Use of unidirectional media in PBB-TE

(supporting 802.1Qay D1.1 comment that PBB-TE service instance return path cannot be required to be co-routed with forward path)

January 2008

Examples of PBB-TE Service Instance

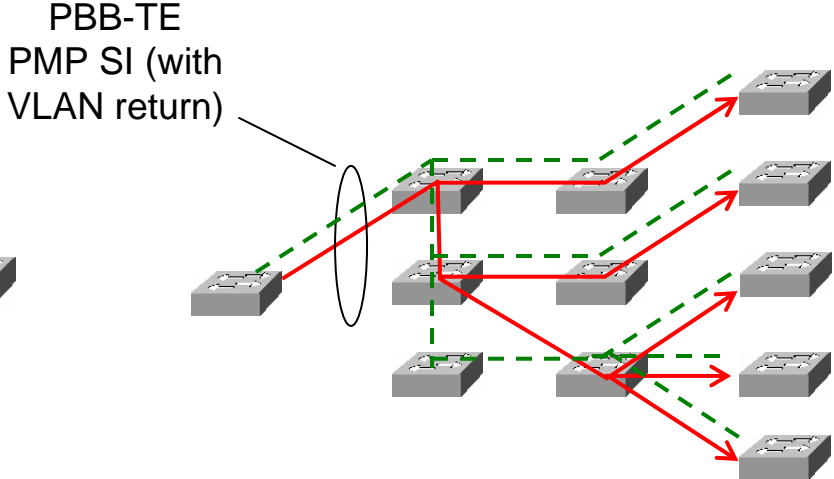
Example shows co-routed VLAN return

Example shows non co-routed VLAN return
